Letter of Transmittal No. 0008

PROJECT: Webster University Interdisciplinary Science Building

RE: Steel Reinforcing Shop Drawings - Level
01 Walls

Subject: 03 3000 Cast-In-Place Concrete –
Steel Reinforcing Shop Drawings –
Level 01 Walls

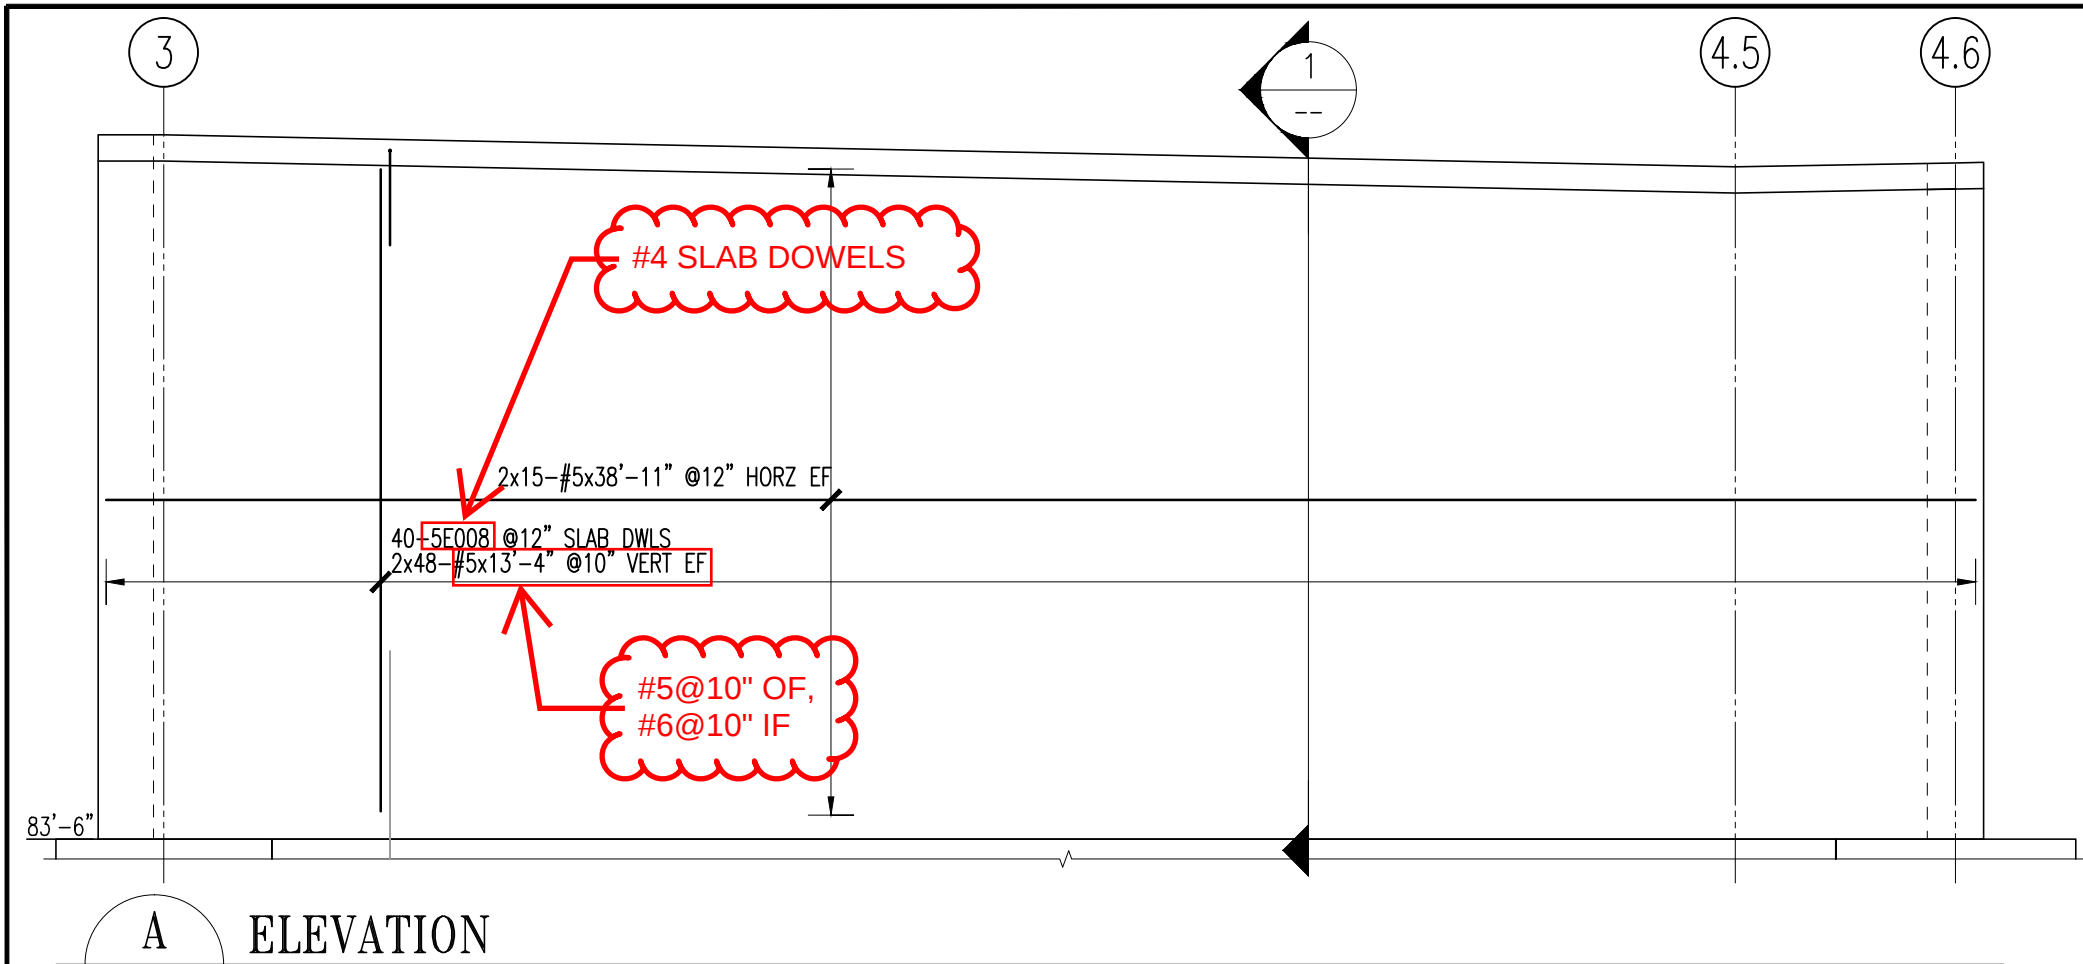
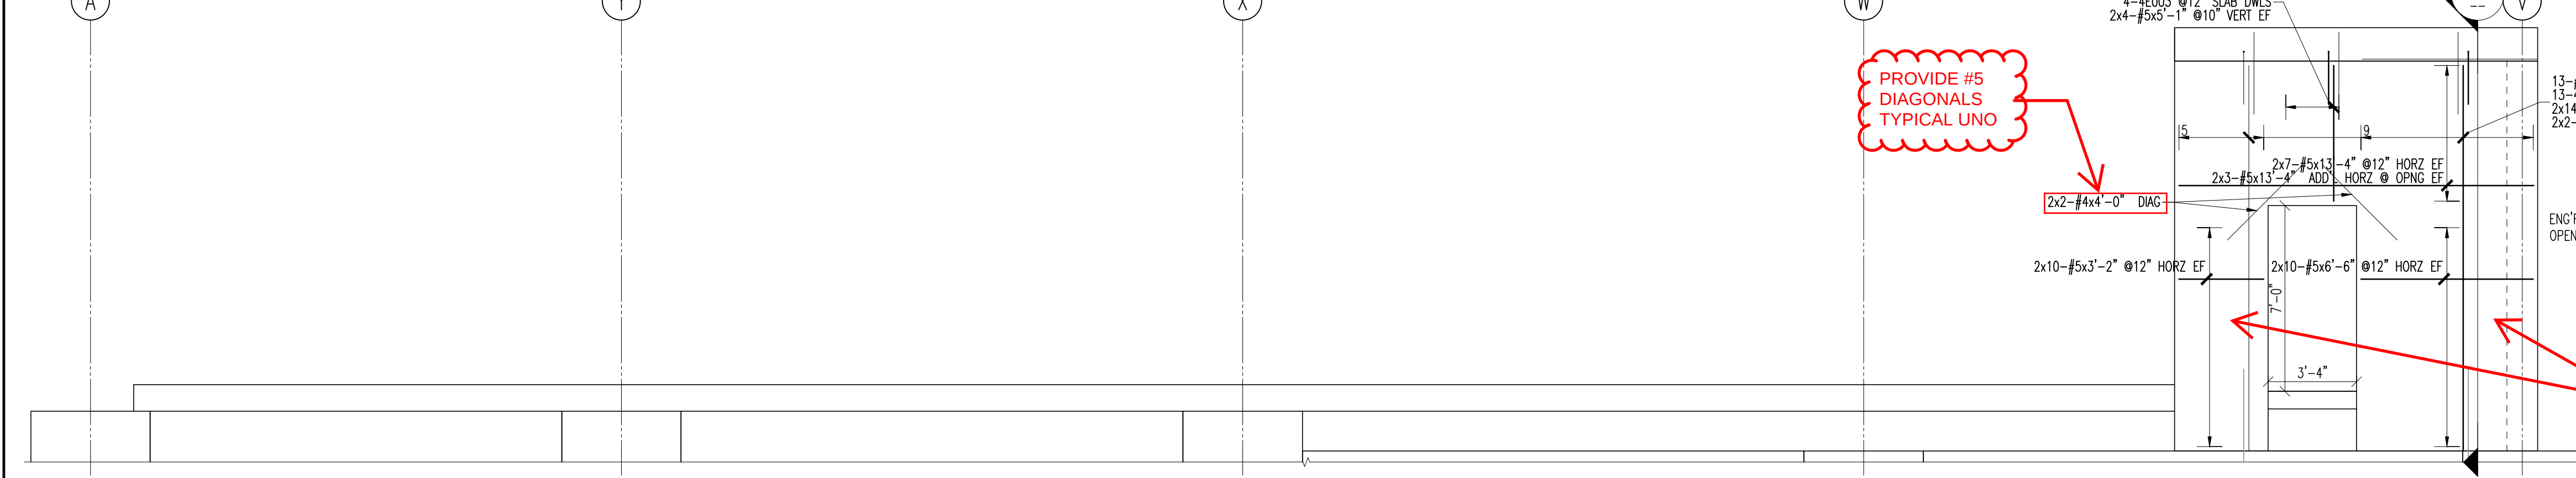
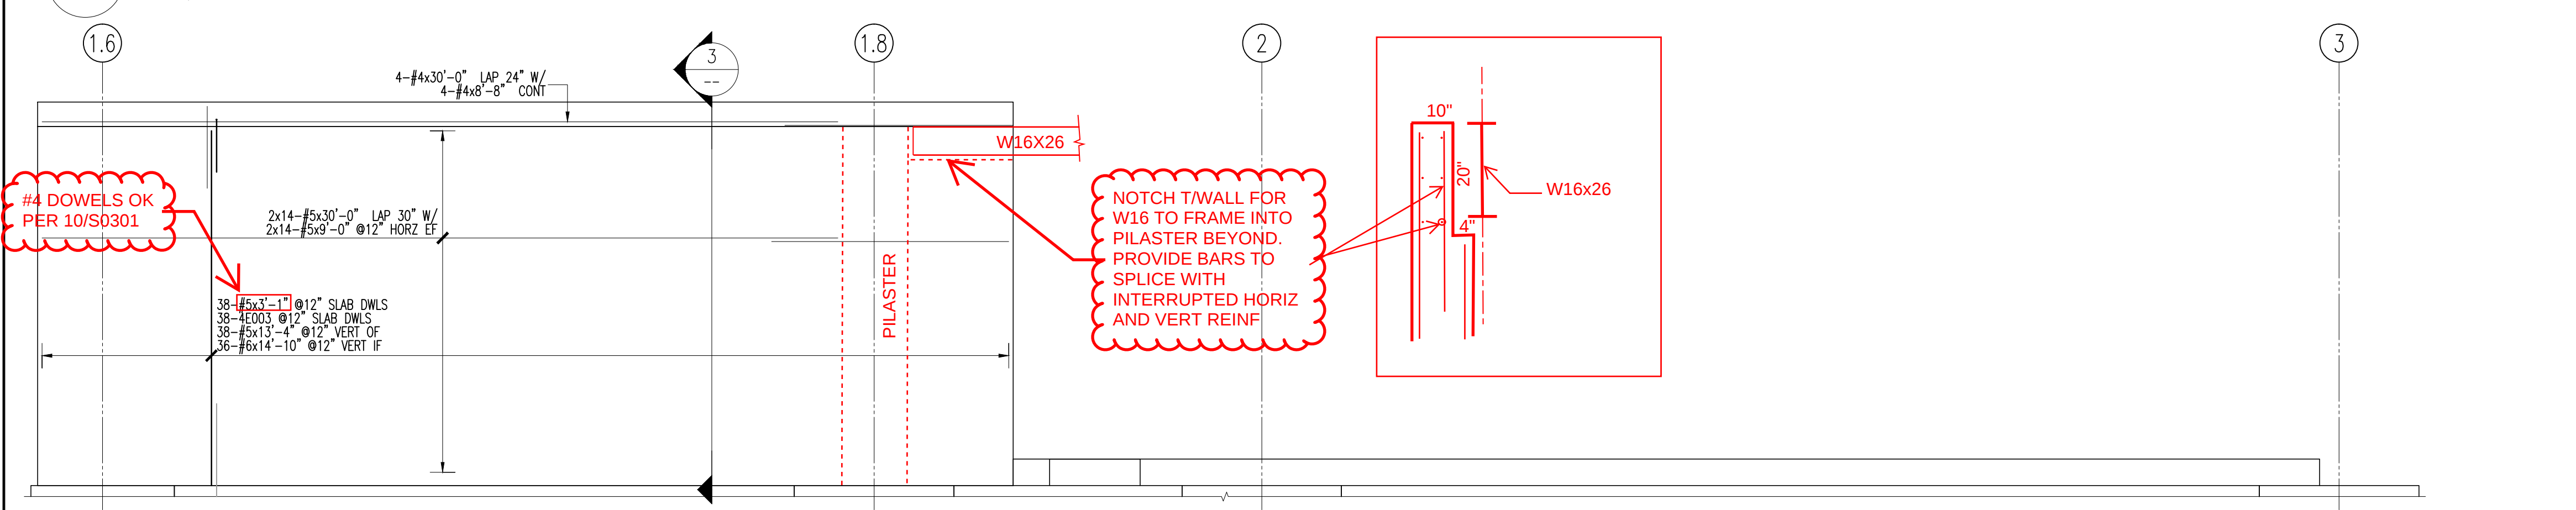
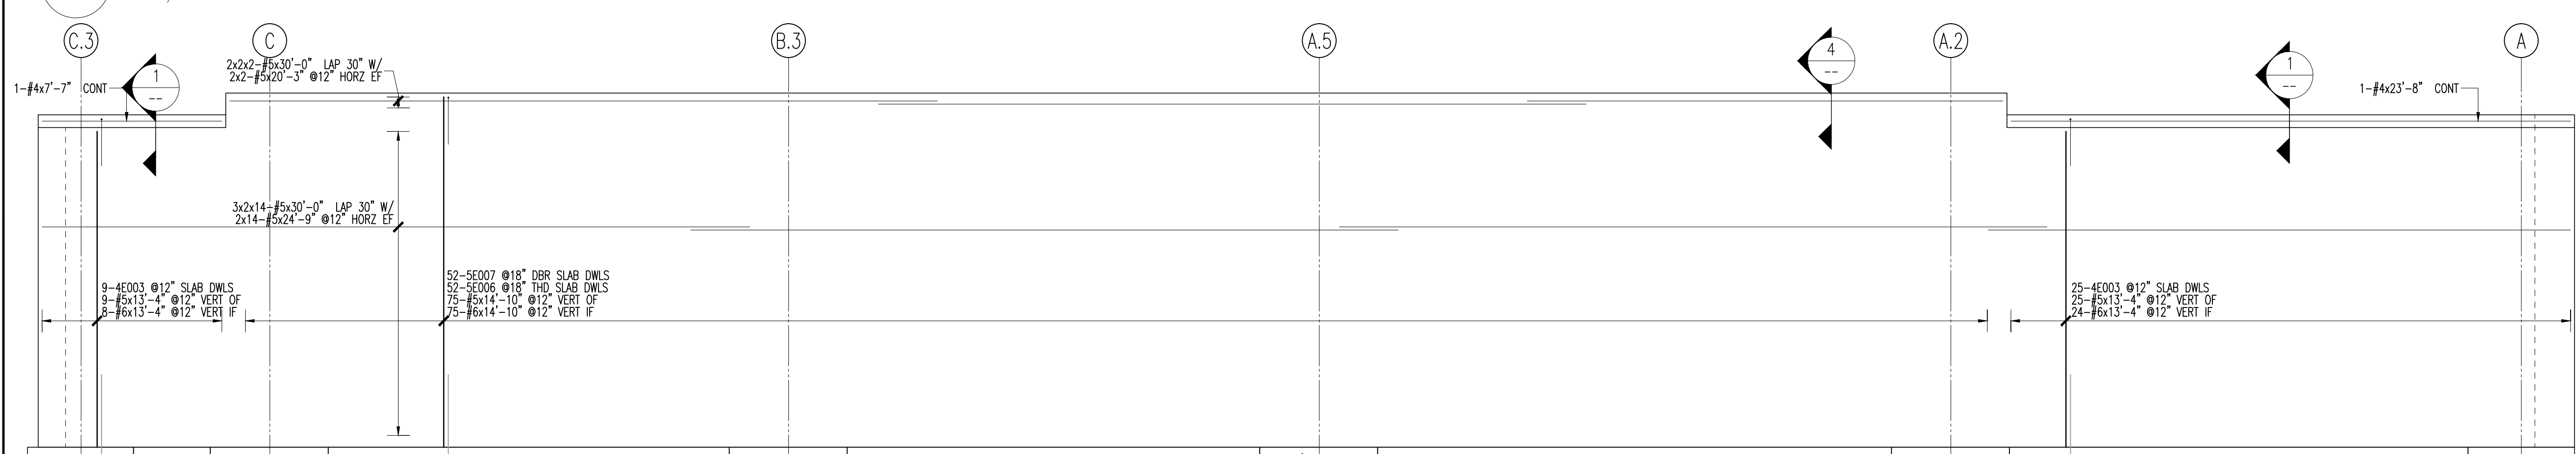
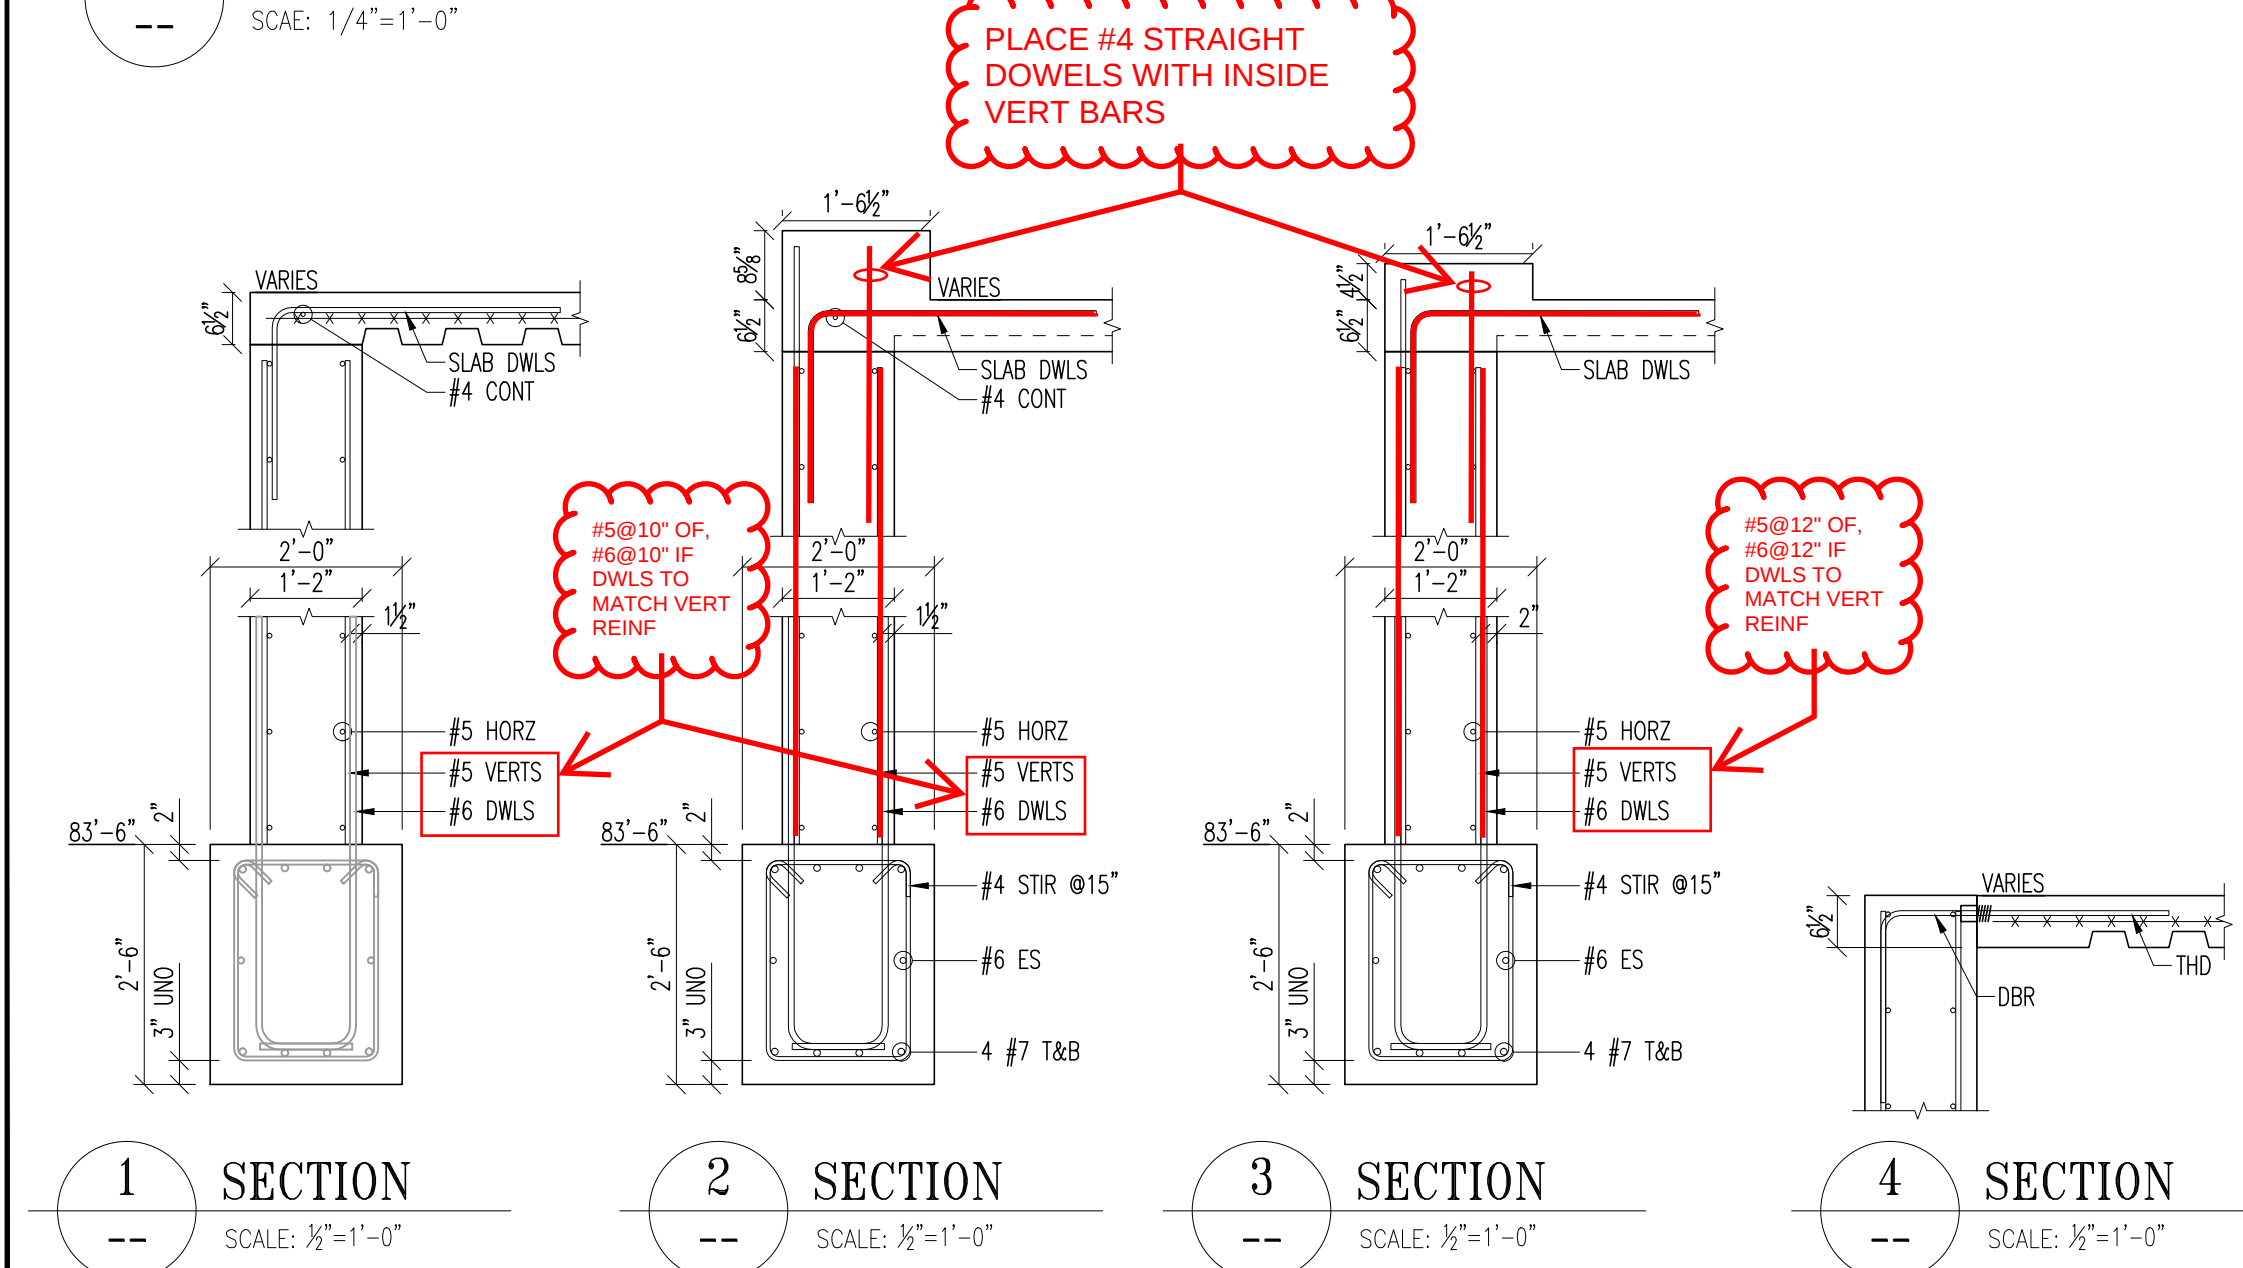
SEE ADD'L/REVISED
INFO ON SHEET R04-01
NOTED IN BLUE

PROVIDE #5 DIAGONALS TYPICAL UNO

WALL REINF IS #5@10"oc OF #6@10"oc IF REVISE REINF
